VPCH Office Expansion  
155 Queen St N  
Hamilton, ON L8R 2V6

**Construction Tender**  
**ARCHITECTURAL ADDENDUM**  
**No. 03**

Friday, October 06, 2023

1 DEMOLITION PLAN - LEVEL 1  
SCALE: 1:75

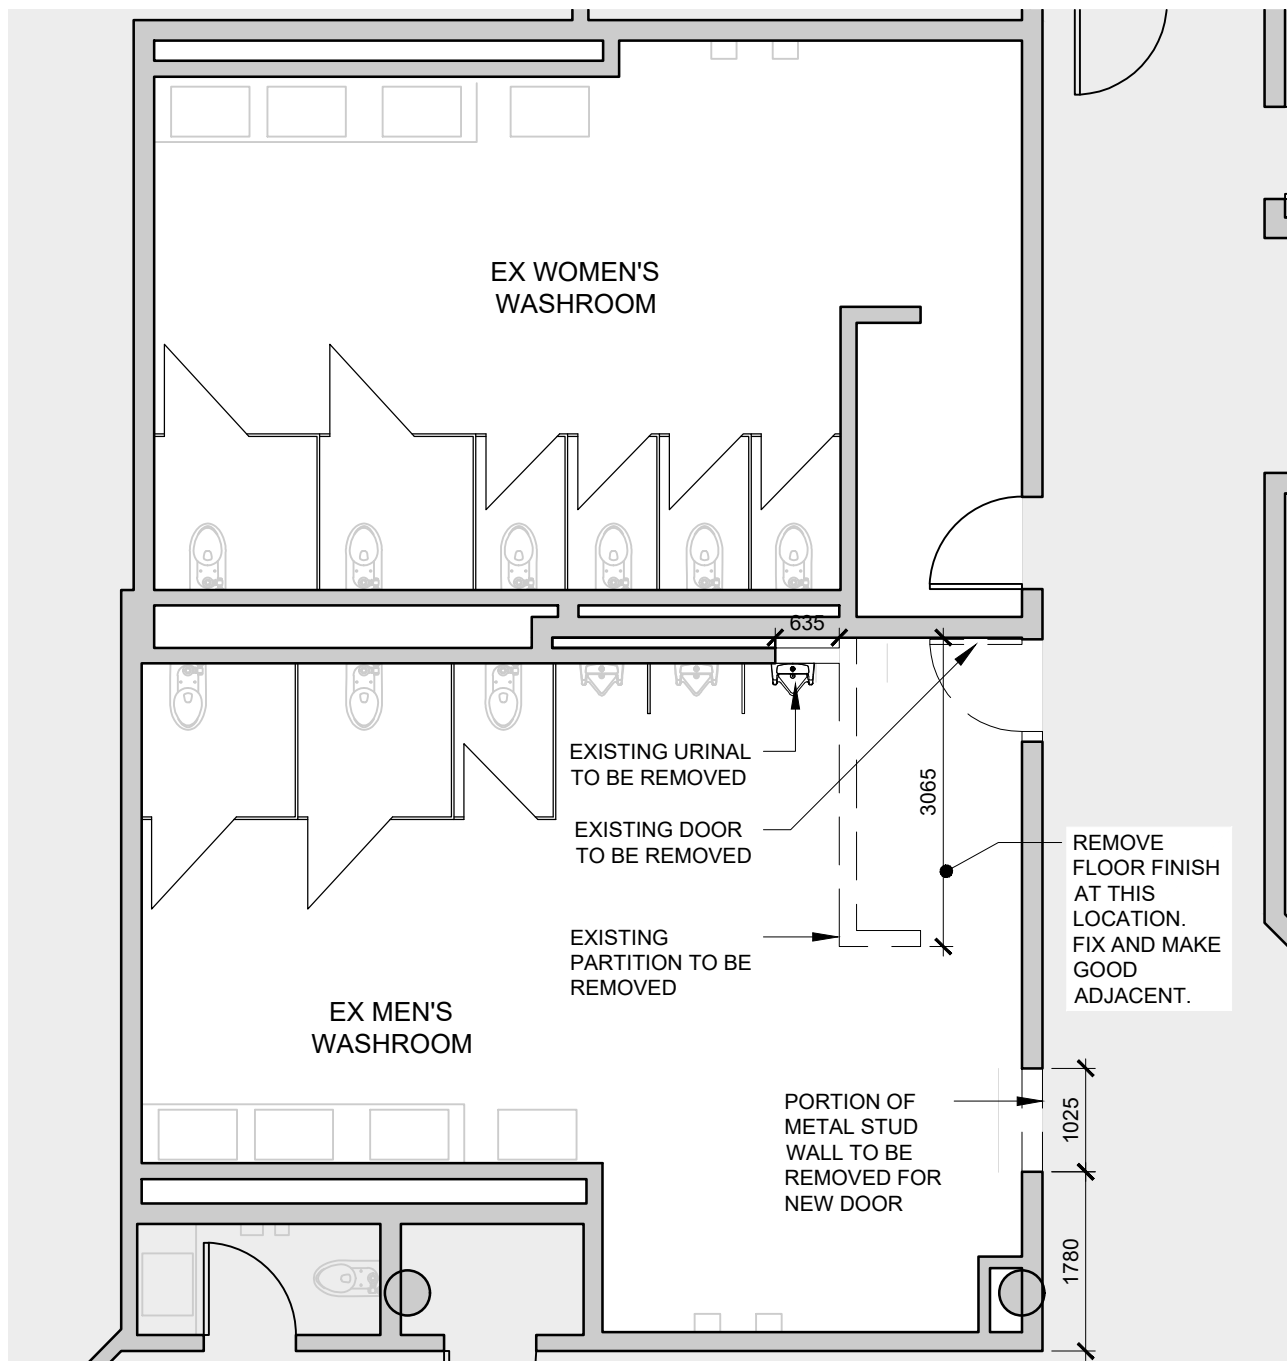
**Response:**

Demo notes have been corrected on the page. Please refer to section 3. DRAWINGS of this addendum. Drawing A01.01 – Demolition Plan Level 1.

## 1 RENOVATION PLAN - LEVEL 1

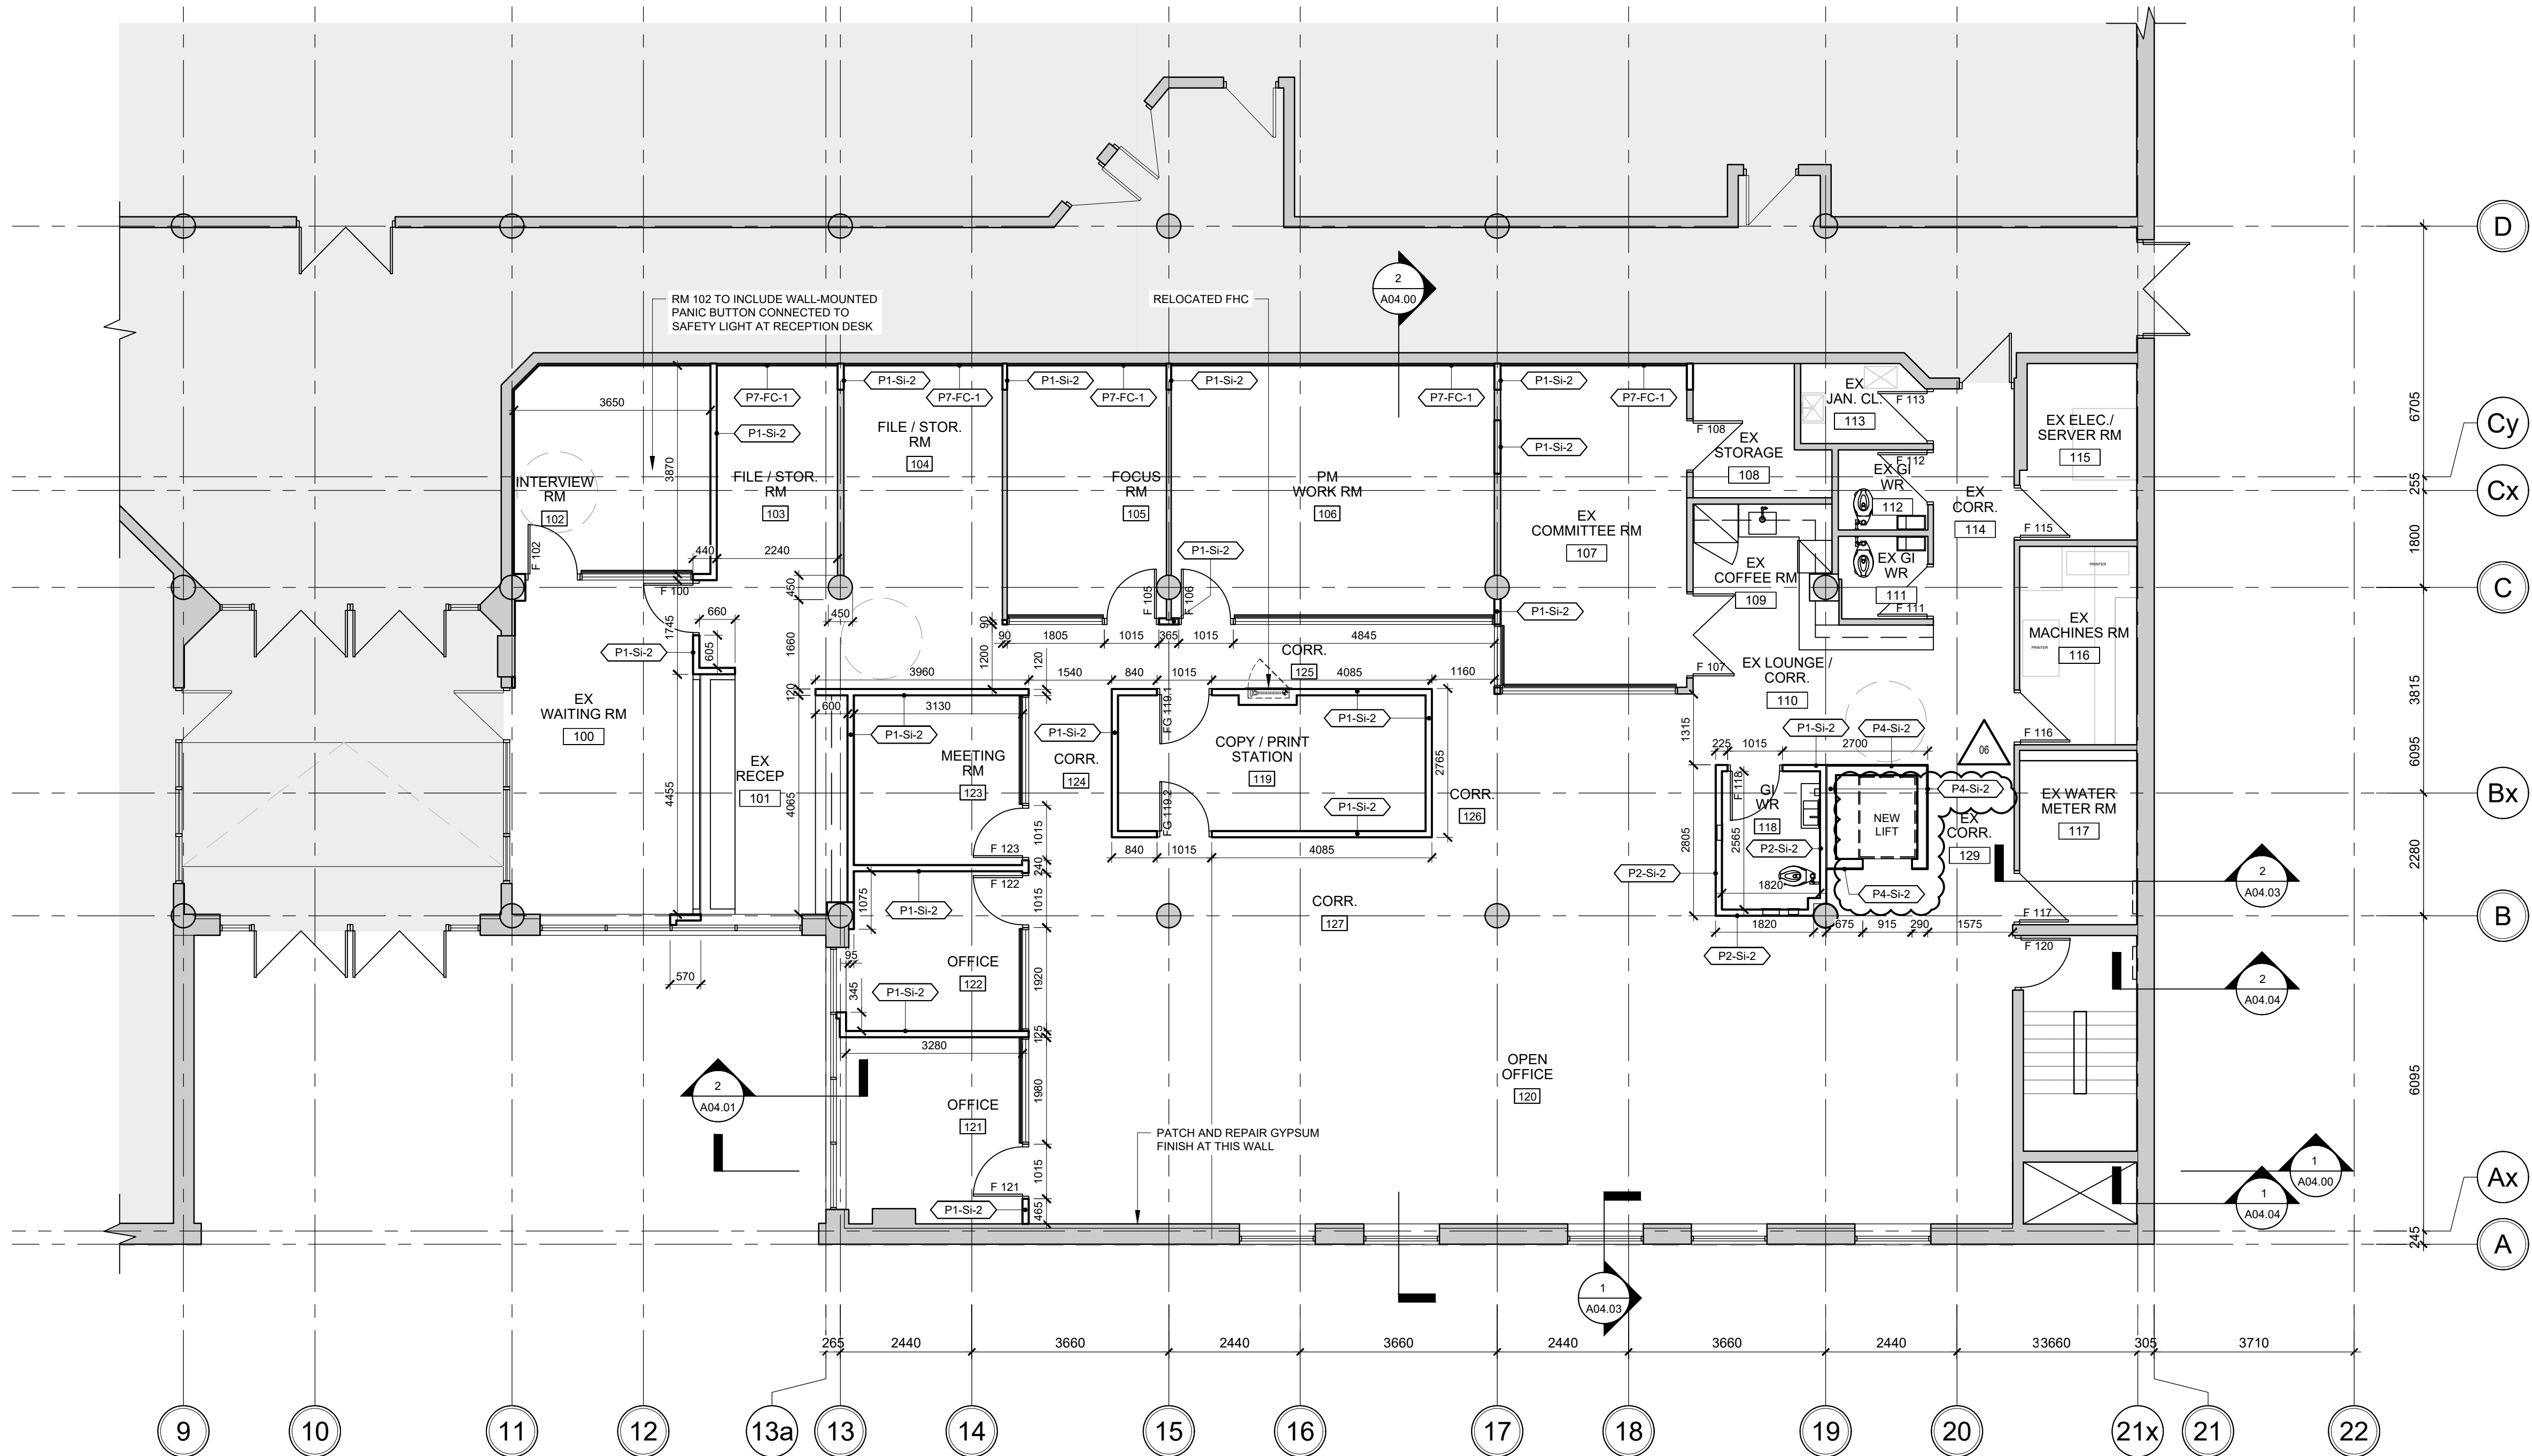
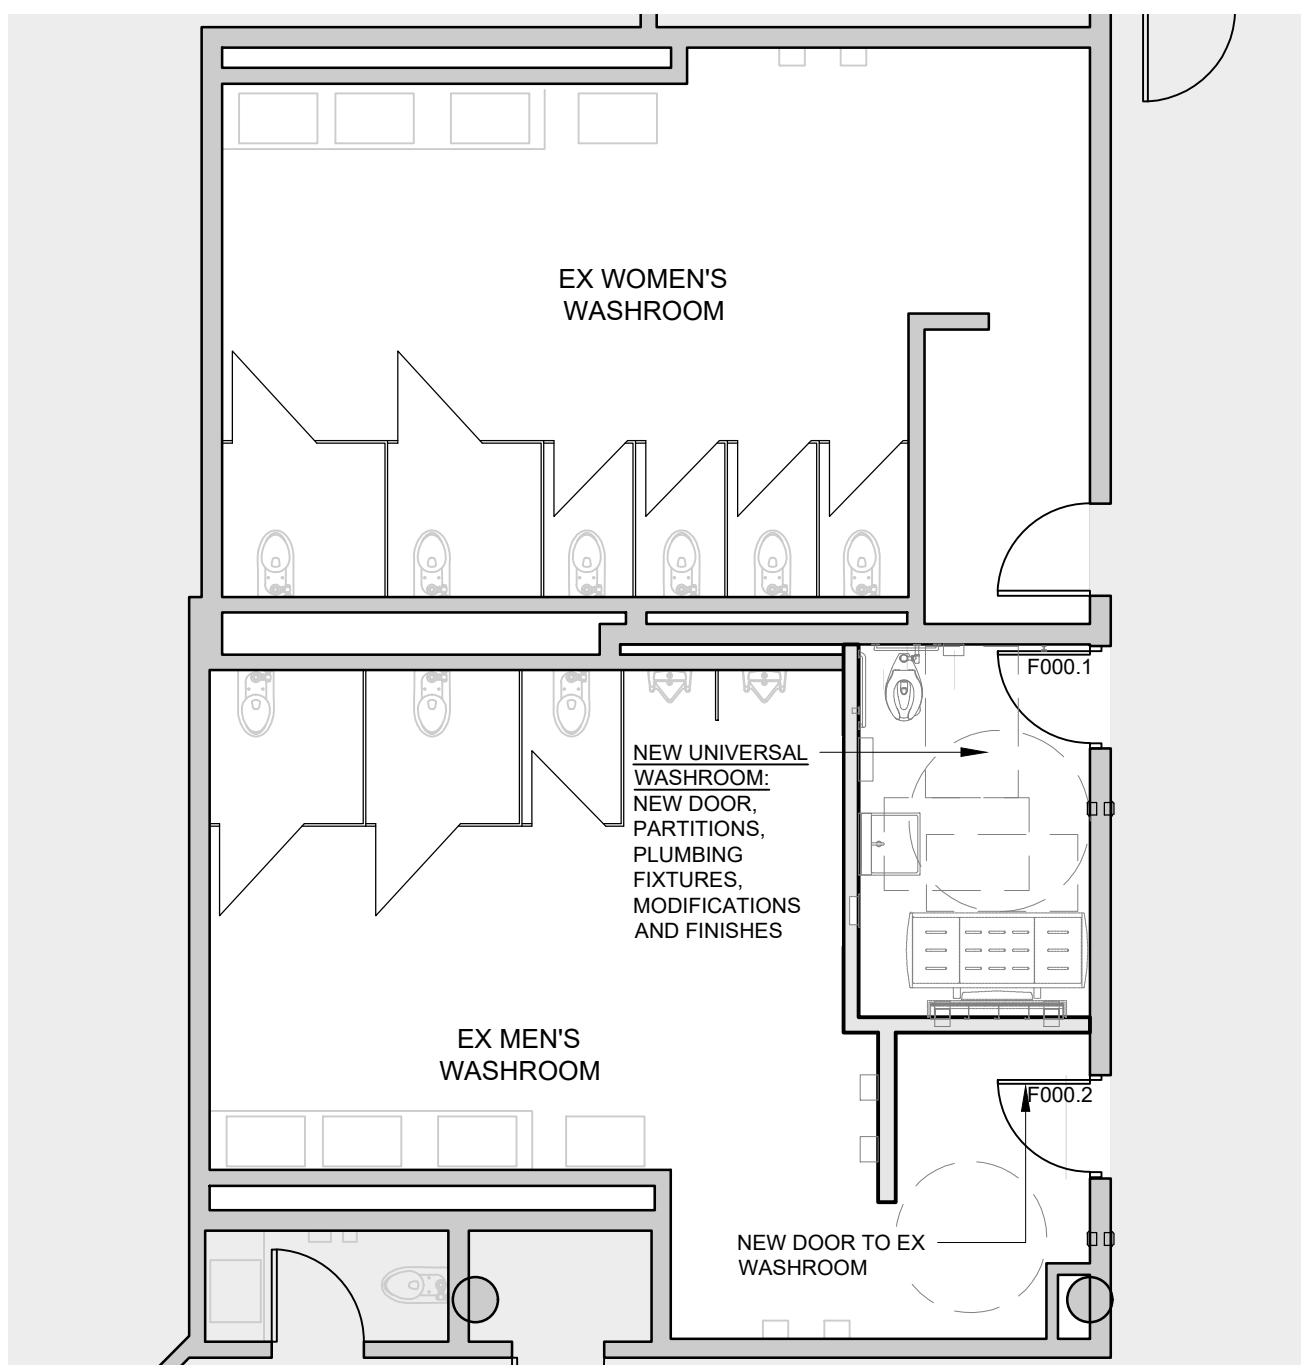
Assemblies schedule on drawing A00.03 notes P5-Si-2 wall type removed but drawing A01.04 notes P5-Si-2 wall type surrounding new lift. Please advise correct wall type.

Please refer to section 3. DRAWINGS of this addendum. Drawing A01.04 – Renovation Plan Level 1 & A01.05 – Renovation Plan Level 2.

1 REFLECTED CEILING PLAN - LEVEL 1  
SCALE: 1:75

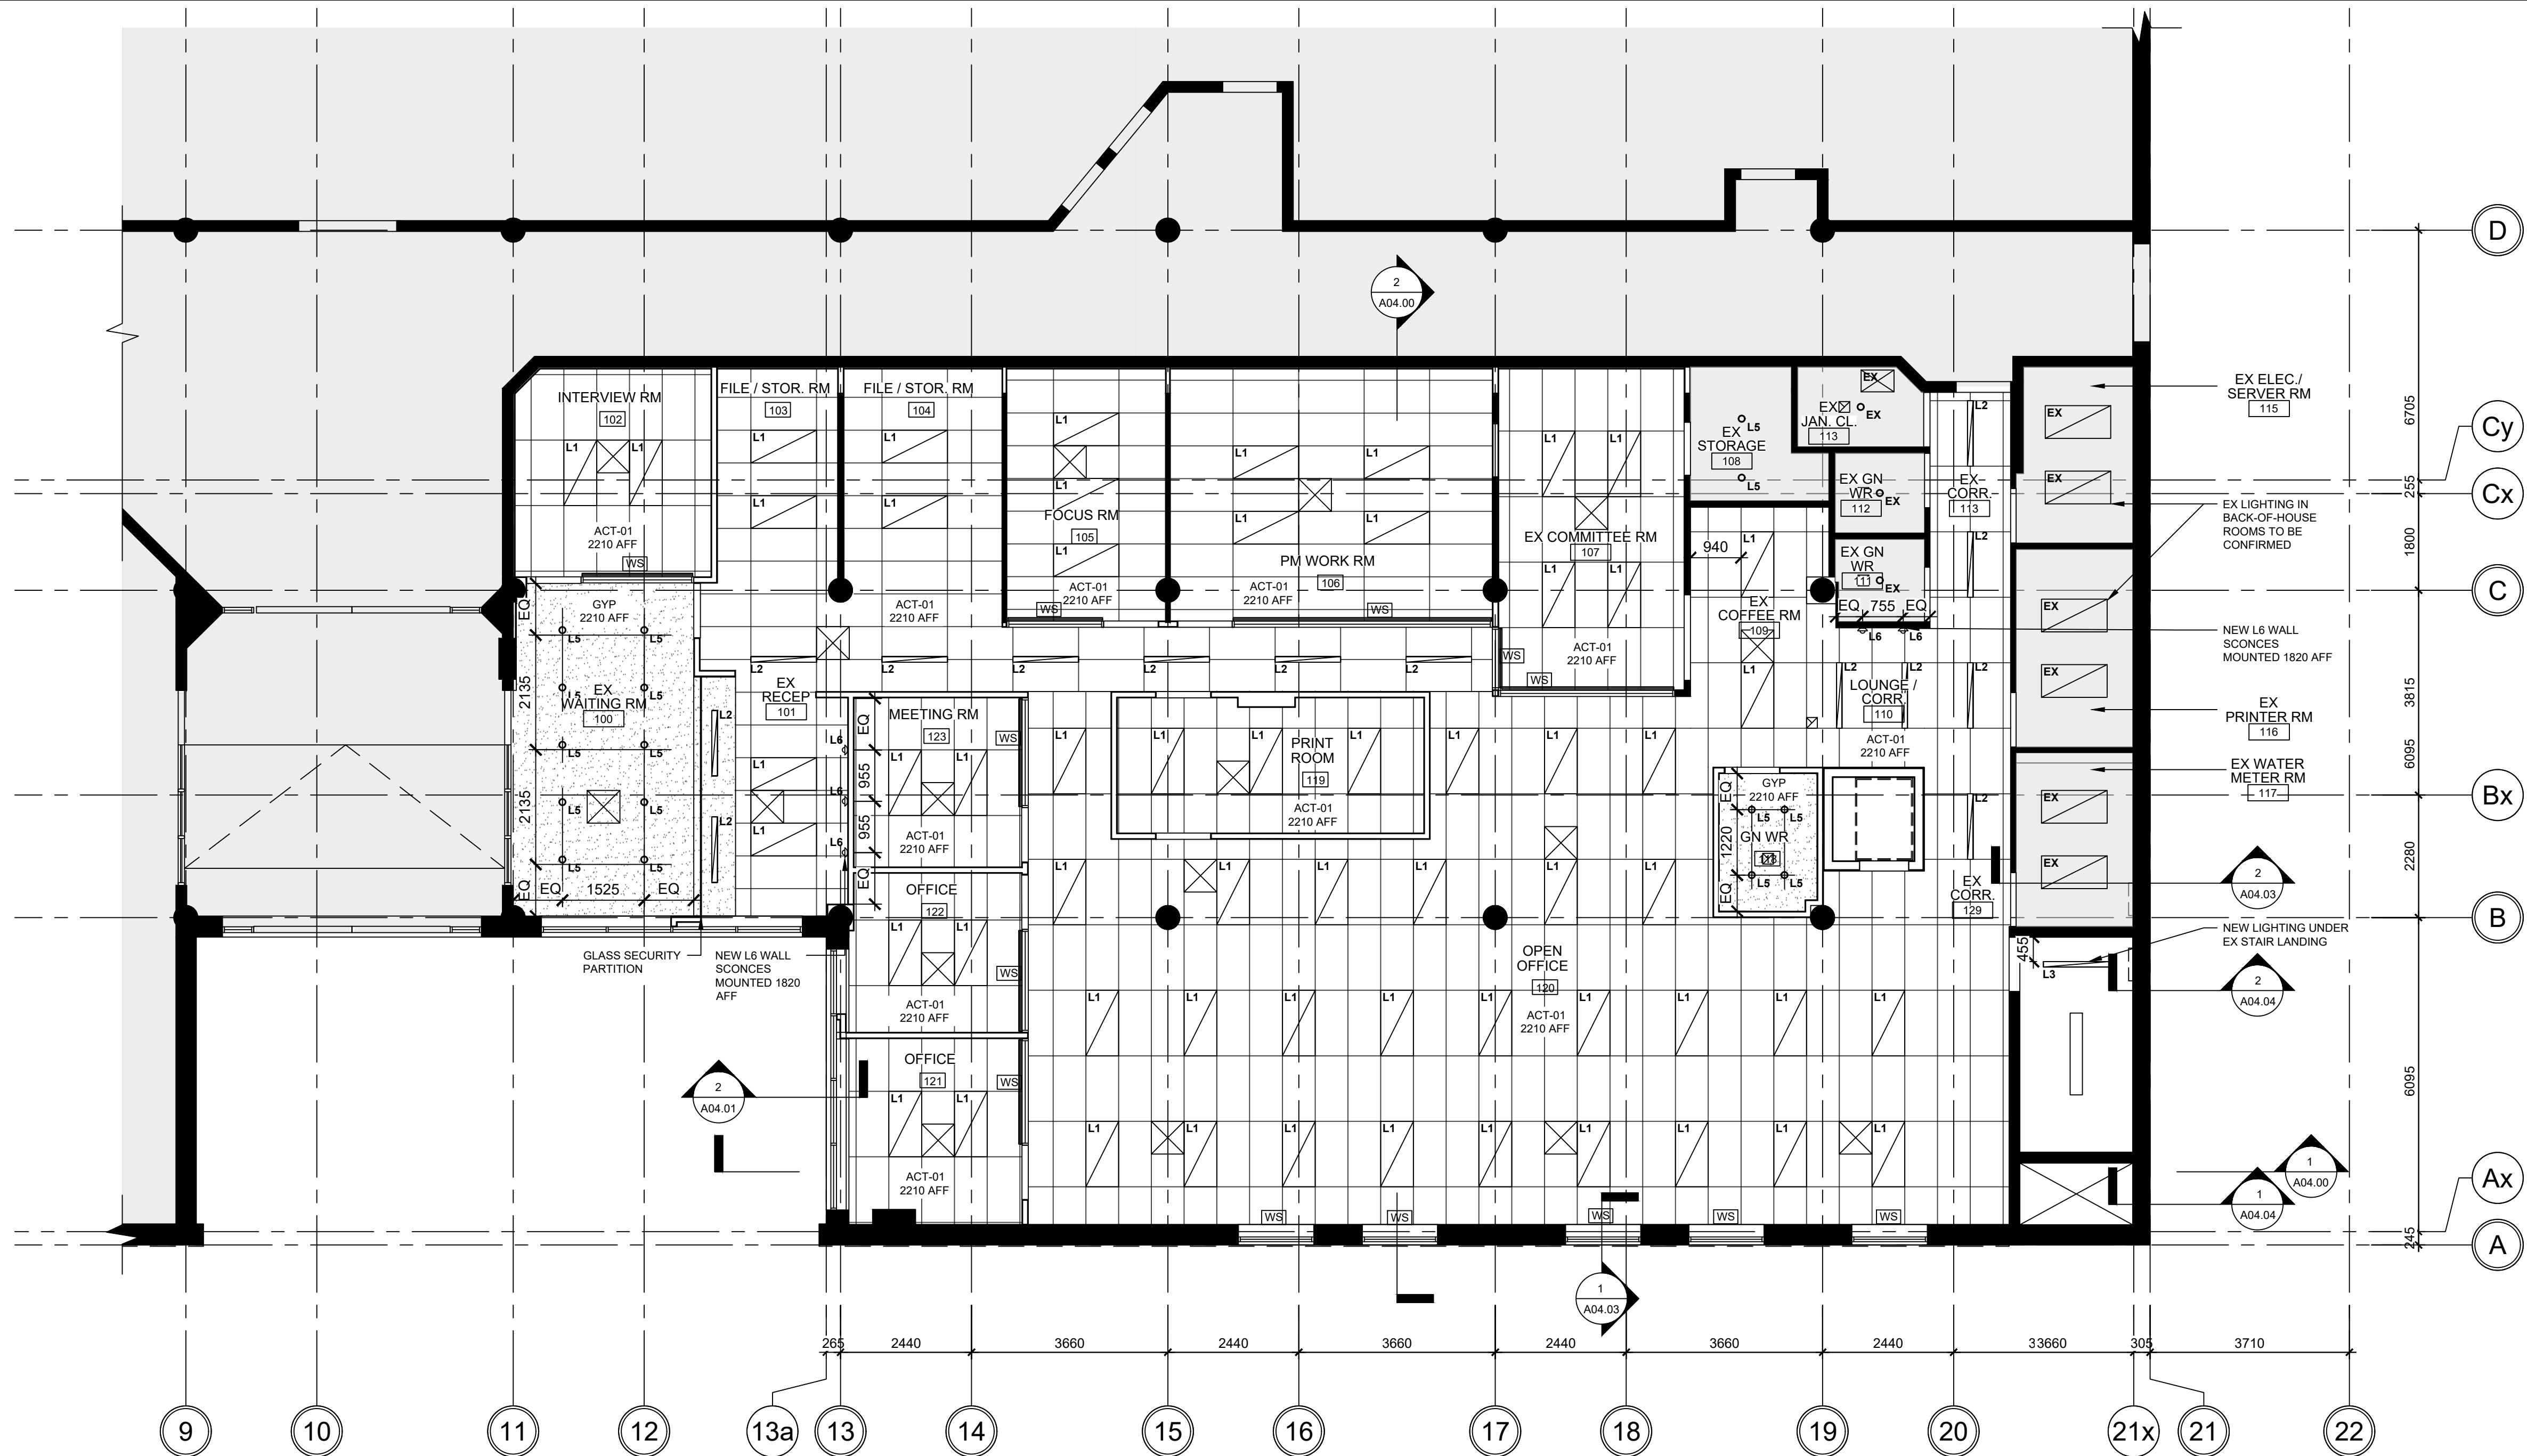
There are blinds shown on Drawing A1.04, in Room 102. Are all other interior glazed walls to receive blinds that are shown with a bold line?

Please provide clarification for the scope of work for roller shades. Drawing A01.09 notes Blind required in room 102. Is this the only shade required?

All offices, interior screen and exterior window shall have a Window Shade. Please refer to section 3. DRAWINGS of this addendum. Drawing A01.13 – Reflected Ceiling Plan Level 1 and A01.14 – Reflected Ceiling

All offices, interior screen and exterior window shall have a Window Shade. Please refer to section 3. DRAWINGS of this addendum. Drawing A01.13 – Reflected Ceiling Plan Level 1 and A01.14 – Reflected Ceiling Plan Level 2. On drawing notation WS – Window Shade.
